# ADA Curb Ramp New Construction Inspection Form (Parallel)

311th	24952.54			Claxter
North-South Road Name	Project No.	Sheet No.	Intersection No.	East-West Road Name
Calibration Date <b>9/20/2024</b> (mm/dd/yy)

PARALLEL RAMP (PL)

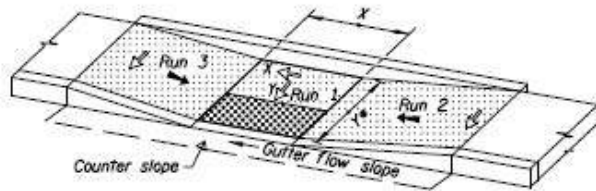
RAMP RUN 1	Pass	Fail
Running Slope 1	<input type="text" value=""/> $\leq 2.0\%$ <input type="checkbox"/> $> 2.0\%$ <input type="checkbox"/>	
Cross Slope 1	<input type="text" value=""/> $\leq 2.0\%$ <input type="checkbox"/> $> 2.0\%$ <input type="checkbox"/>	
Detectable Warning	<input type="text" value="Y"/> Y <input checked="" type="checkbox"/> N <input type="checkbox"/>	
Lip Height	<input type="text" value="0"/> $\leq 1/4"$ <input checked="" type="checkbox"/> $> 1/4"$ <input type="checkbox"/>	
Gutter Flow Slope	<input type="text" value="0.7"/> $\leq *$ <input checked="" type="checkbox"/> $> *$ <input type="checkbox"/>	
Curb Running Slope (avg)	<input type="checkbox"/> <input type="text" value="2.4"/> $\leq 8.3\%$ <input checked="" type="checkbox"/> $> 8.3\%$ <input type="checkbox"/>	
Counter Slope (+/-)*2	<input type="text" value="5.2"/> $\leq  5.0\% $ <input type="checkbox"/> $>  5.0\% $ <input checked="" type="checkbox"/>

RAMP RUN 3	Pass	Fail
Running Slope 3	<input type="text" value=""/> $\leq 8.3\%$ <input type="checkbox"/> $> 8.3\%$ <input type="checkbox"/>	
Length 3	<input type="text" value="7.25"/>	
Cross Slope 3	<input type="text" value="3.6"/> $\leq 2.0\%$ <input type="checkbox"/> $> 2.0\%$ <input checked="" type="checkbox"/>

IITD, gt2. BOR sign.
